RAI: Volume 3, Chapter 2.2.1.3.1, Second Set, Number 11:

1. RESPONSE

Figure 1. Mean Fraction of Locations in Each Percolation Subregion That Will Experience Localized Corrosion Initiation after the Drip Shield Fails as a Function of Drip Shield Failure Time (SNL 2008, Figure O-2 of ERD05)

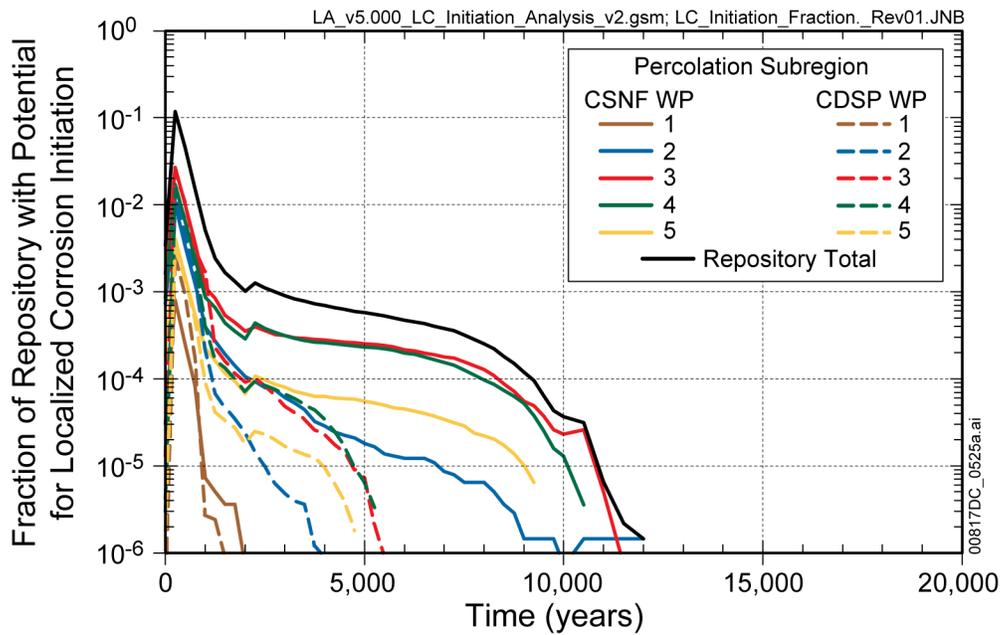
The main results of the localized corrosion initiation uncertainty analysis are shown in Figure 1. The results show the mean fraction of repository locations with the potential for localized corrosion initiation (either by salt separation or corrosion potential) as a function of the drip shield failure time. Note that there are two differences between these results and the results from the original analyses shown in Figure 2. The original analysis did not include salt separation. In addition, the original analysis only showed the instantaneous fraction of nodes where localized corrosion would initiate, whereas the updated results show the final fraction of nodes that would initiate, either immediately or in the future after the drip shield failure time.

In Figure 1, the effects of salt separation and corrosion potential are combined. The maximum of the mean fraction of nodes with potential for localized corrosion initiation is about 0.34. In contrast, Figure 2 shows the fraction of locations with potential for localized corrosion due only to electrochemical corrosion potential conditions. Because the maximum mean fraction of locations shown on Figure 2 is about 0.1, the mean fraction of locations with potential for localized corrosion due only to salt separation is roughly 0.24. The increase in the total number of nodes at which localized corrosion could initiate from 10% to 34% is due to inclusion of the salt separation process. However, salt separation only contributes to the potential for localized corrosion initiation for about 1,000 years. Beyond 1,000 years, the relative humidity at the waste packages rises above the precipitation threshold, thus precluding future salt separation on the waste package surface. Consequently, after 1,000 years, Figure 1 and Figure 2 are quantitatively similar and show only the effect of the electrochemical corrosion potential because salt separation can no longer occur. The numbers in the two figures are slightly different, again, because Figure 2 shows only instantaneous values whereas Figure 1 also includes waste packages on which localized corrosion initiates at some time after drip shield failure.

As indicated by Figure 1, the conditions for any type of localized corrosion initiation do not occur beyond 12,000 years. If the drip shield remains intact for 12,000 years, localized corrosion of the waste package will not occur.

Figure 3. Expected Annual Dose over 10,000 Years from Seismic Ground Motion Events That Result in Drip Shield Plate Failure Including Salt Separation (SNL 2008, Attachment 2 of ERD 05)

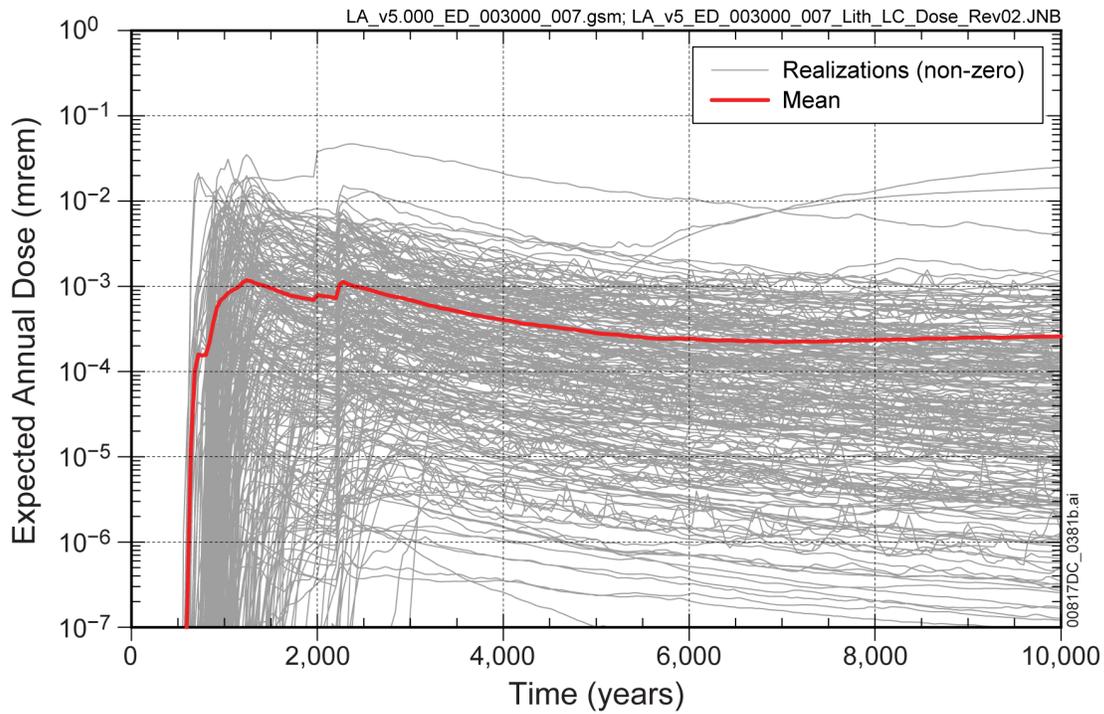
Figures 3 and 4 show the 10,000-year distribution of expected annual dose from seismic ground motion events that result in drip shield plate failure, and compare the original results (without salt separation) to the updated results (with salt separation). The effect of including salt

separation can be observed in several aspects: the earlier rise time of the expected annual dose (mean appearing just before 500 years instead of just after); a greater maximum in the mean annual dose by about a factor of three; and a narrower distribution of results due to increases in the lower range of the distribution.

To determine whether the contribution to expected annual dose from the combination of drip shield failure and localized corrosion of the waste package is significant, the mean annual dose from Figure 3 is compared to the mean annual dose from the seismic ground motion modeling case for 10,000 years post-closure (SAR Figure 2.4-25a, reproduced here as Figure 5). The distribution of expected annual dose shown in Figure 5 results from considering only the annual dose resulting from seismically induced damage (i.e., stress-corrosion cracking) of co-disposal waste packages. The comparison between Figure 3 and Figure 5 shows that the mean annual dose considering drip shield failure and localized corrosion is substantially less than the mean annual dose calculated in the seismic ground motion modeling case, except just before 1,000 years post-closure. From about 800 to 1,000 years post-closure, the initial peak of the mean annual dose from the combination of drip shield failure and localized corrosion of the waste package rises to about 3×10^{-3} mrem, and is somewhat greater than the mean annual dose in the seismic ground motion modeling case. However, after 1,000 years post-closure the mean annual dose in the seismic ground motion modeling case significantly exceeds the mean annual dose from the combination of drip shield failure and localized corrosion of the waste package. Most importantly, the mean annual dose considering drip shield failures is less than 5×10^{-3} mrem during 10,000 years, which is not numerically significant compared to the maximum mean annual dose in the seismic ground motion modeling case for 10,000 years (about 0.2 mrem). Thus, inclusion of salt separation in the localized corrosion initiation uncertainty analysis has a negligible effect on the results of the seismic ground motion modeling case for 10,000 years post-closure.

The results shown in Figure 3 are also applicable when considering the potential effect of localized corrosion on the seismic ground motion modeling case for 1,000,000 years. The same qualitative conclusion is reached here as in the 10,000-year period (compare Figure 3 with SAR Figure 2.4-25b), in that the contribution to the mean annual dose from the combination of drip shield failure and localized corrosion is not significant during the first 10,000 years post-closure. The fully probabilistic seismic ground motion modeling case for 1,000,000 years considers the combined effects of general corrosion of drip shield materials and of seismic events (e.g., drift degradation) to determine the time of drip shield failure. The results of this modeling case show that no drip shield failures are estimated to occur before 12,000 years (SNL 2008, p. 8-66[a] and Figure 8.3-7[a]), and consequently inclusion of salt separation has no effect on the mean annual dose for this modeling case.
